NOTICE OF DECISION TO CONSENT TO AMEND A REFERRED PROPOSAL DURING ASSESSMENT

Ridley Magnetite Project
Assessment No. 2362; APP-0000162

Ridley Magnetite Project

Proposal Content Document

Original Proposal

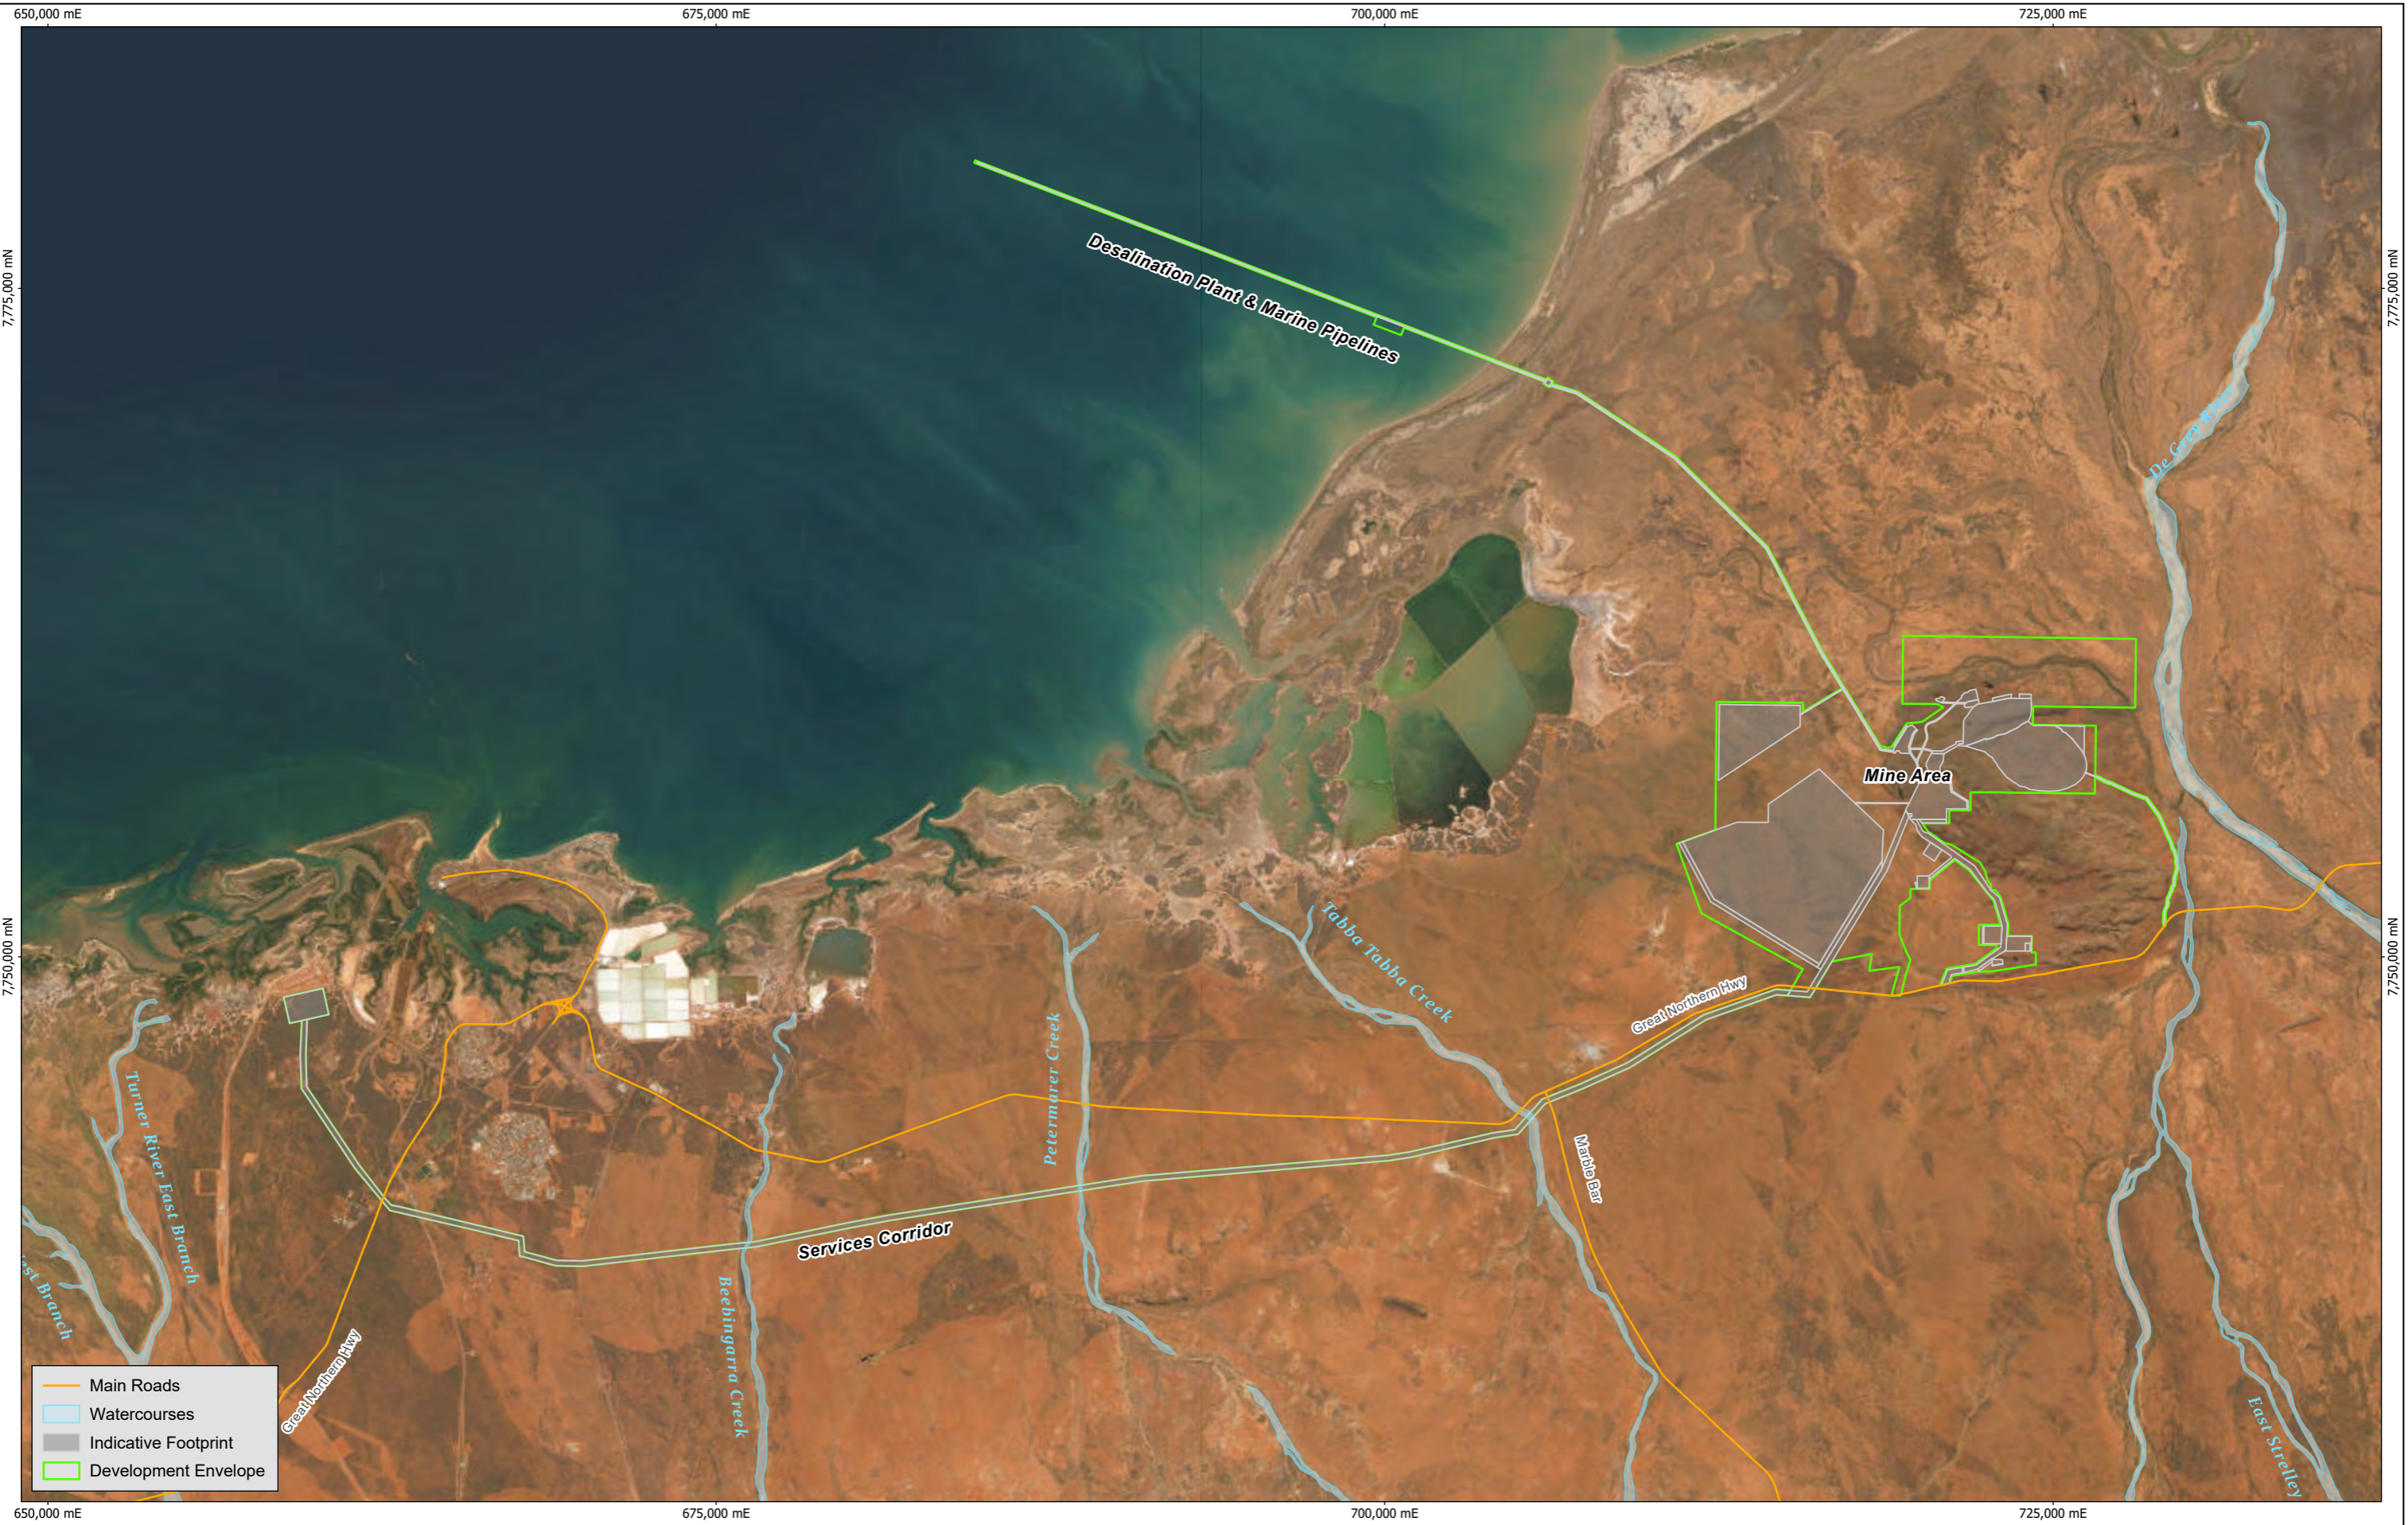
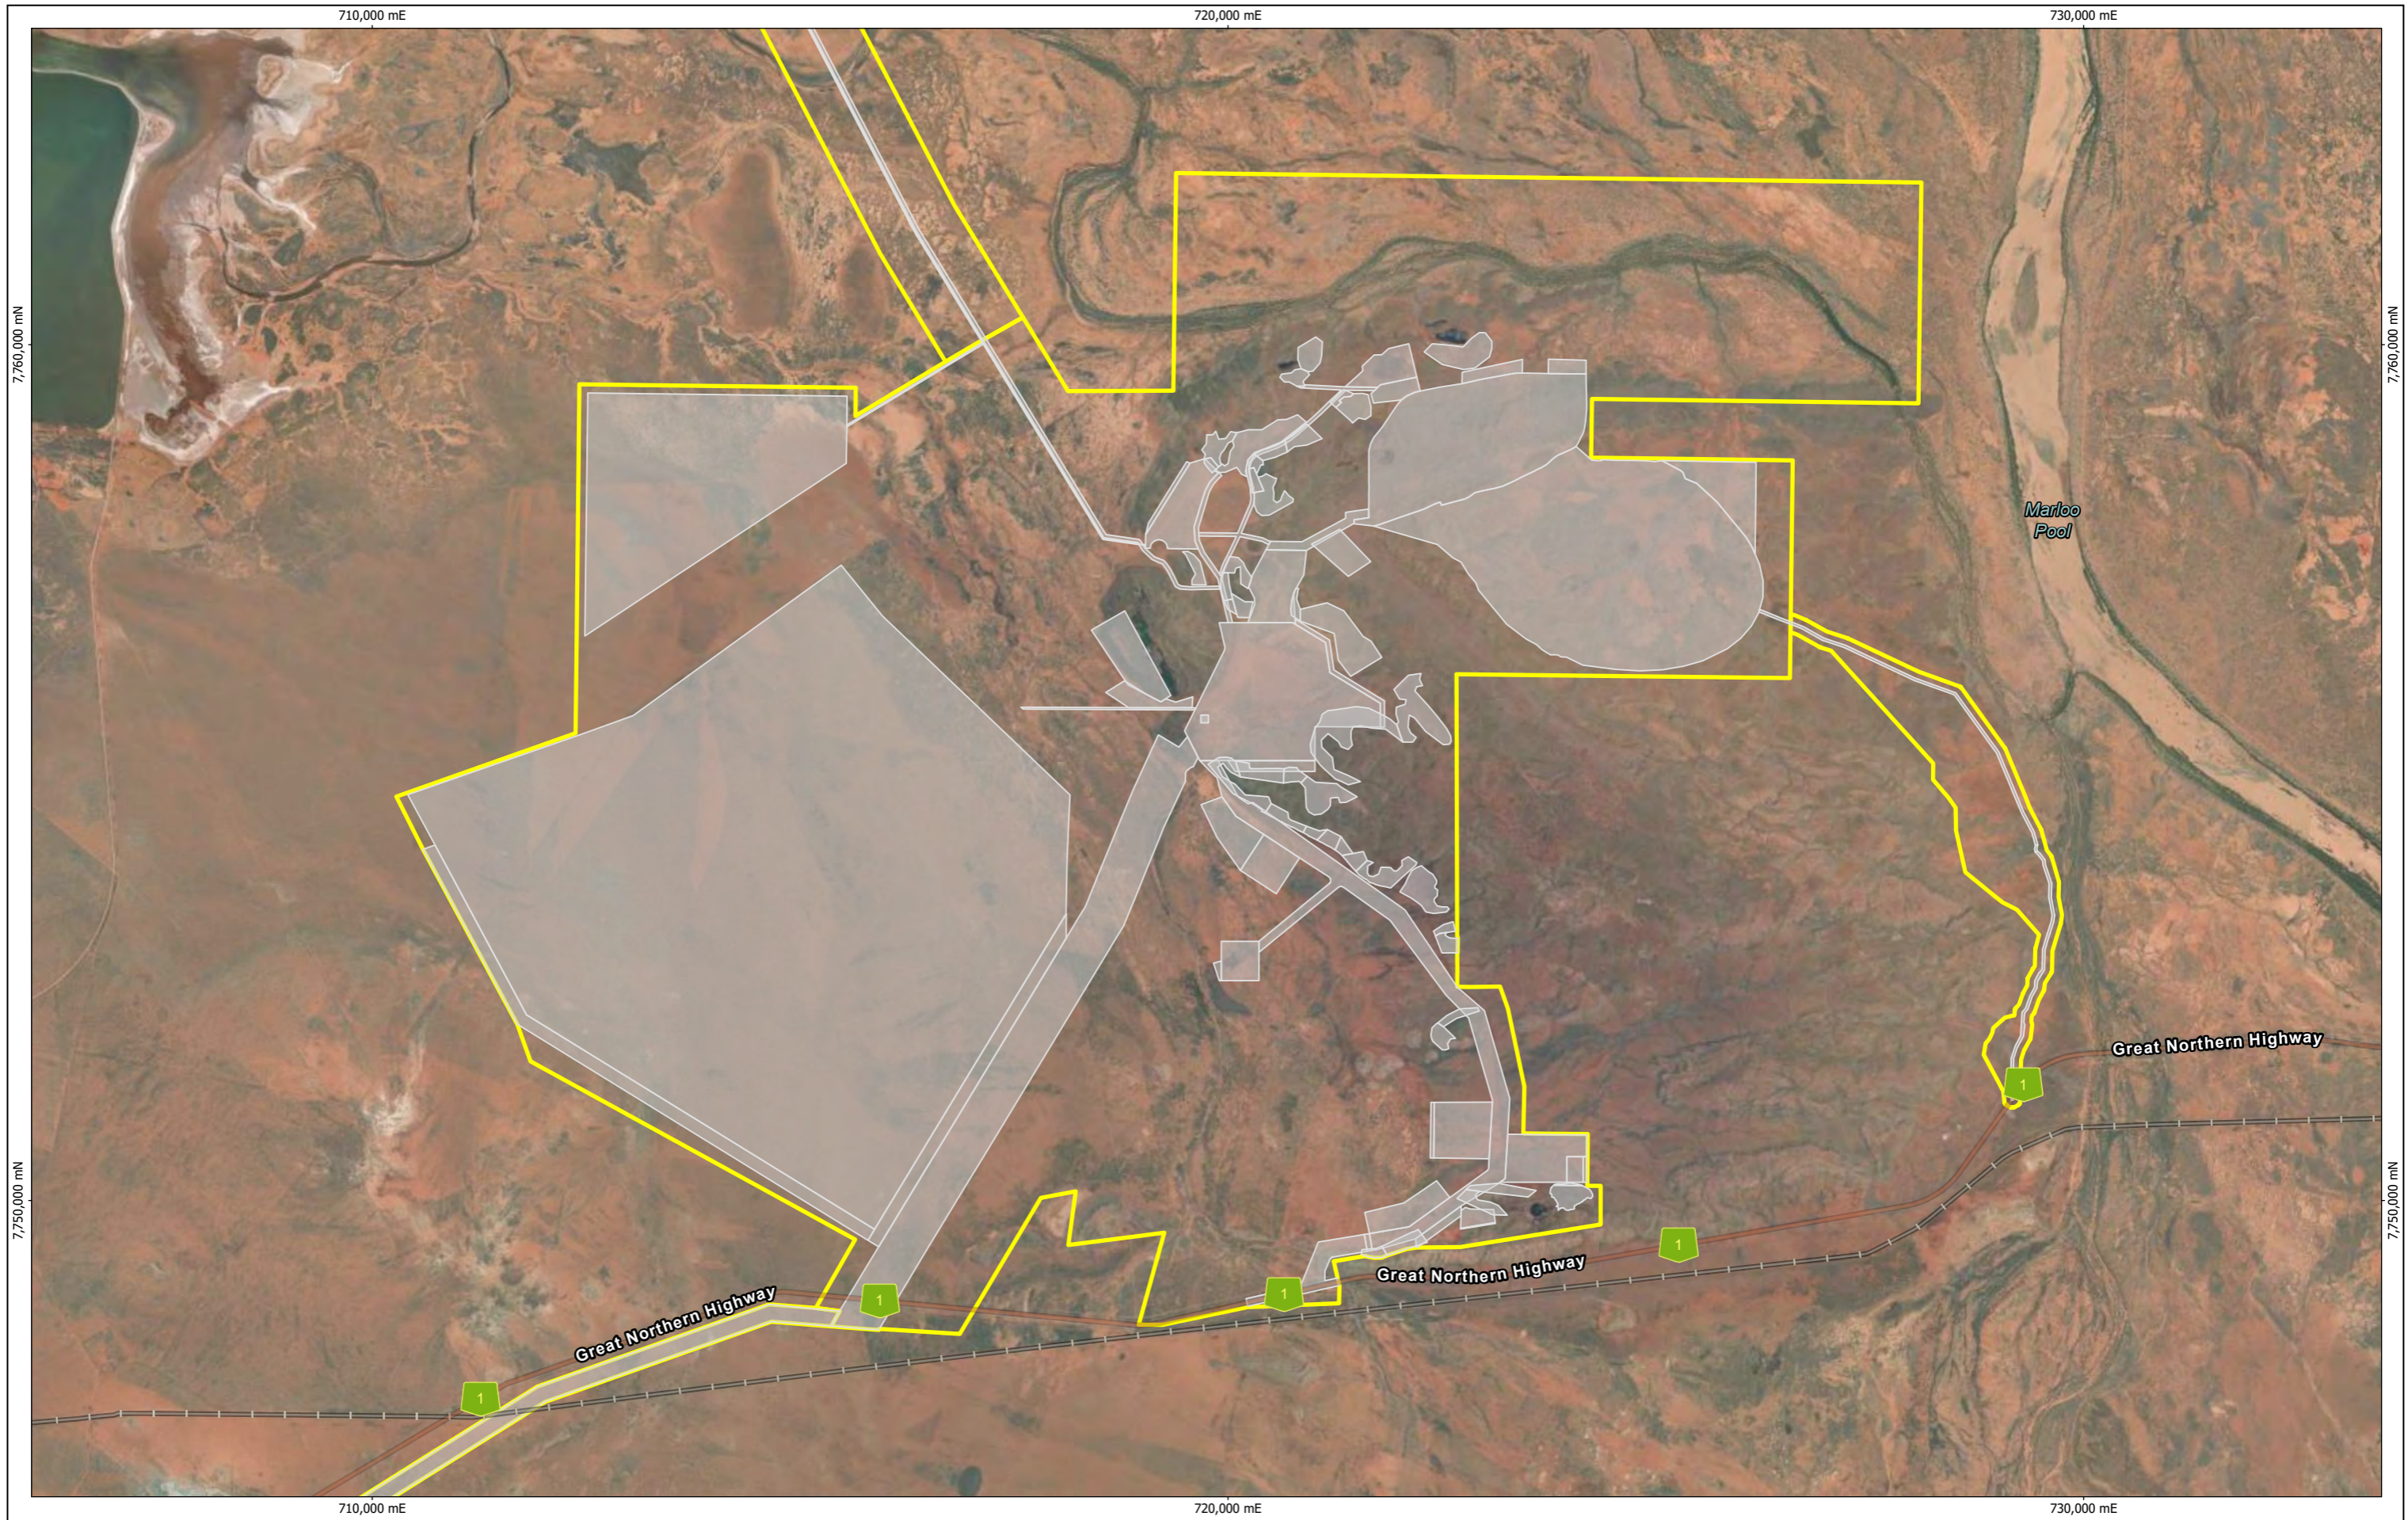
- Removal of the proposed 20 kilometre desalination plant marine intake and outfall pipe structures and inclusion of an approximately 500 metre jetty structure into the marine environment to support intake and outfall pipelines.

- Modifications and an overall increase to the development envelope by 4,921 hectares (ha) (from 14,181 ha to 19,102 ha) as shown in the attached figures, and comprising:

- 1,701 ha increase due to an increase in the width of the desalination plant pipeline corridor to 1,000 m.
 - 601 ha increase associated with the realignment of the slurry pipeline at Port Hedland.

- 297 ha increase due to an increase in the width of the eastern road corridor, to 200 m, and the inclusion of borrow pits along the road alignment.
 - 2,235 ha increase due to changes to the layout of supporting infrastructure, such as the accommodation camp.

- 87 ha increase associated with an increase in the size of the desalination plant.
- Increase the indicative disturbance footprint by 1,078 ha (from 7,406 ha to 8,484 ha).
